Former Packway Garage, The Packway, Larkhill, SP4 8PZ

Previous Planning Permissions

SOUTH / FRONT

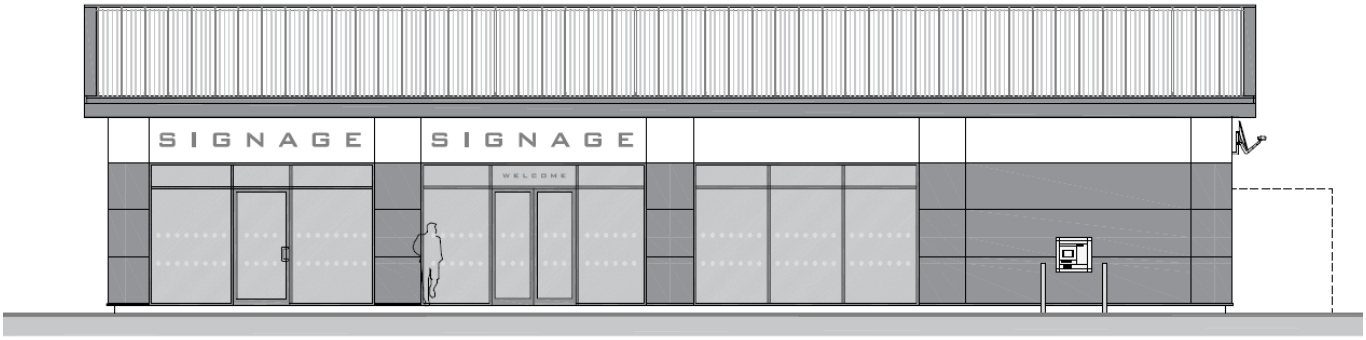
The front elevation to the above approved application has an ATM proposed to the front elevation in the following position:

The wind-bracing of the structural steel frame interferes with the position of the ATM in the position approved by PL/2021/05433. Furthermore, the ATM is not in a desired position to suit an internal store layout, and therefore a revised position is proposed which is acceptable to store design and the engineers of the development, and does not interfere with structural components.

The revised proposal is only a slight variation in the proposed ATM position, to the following:
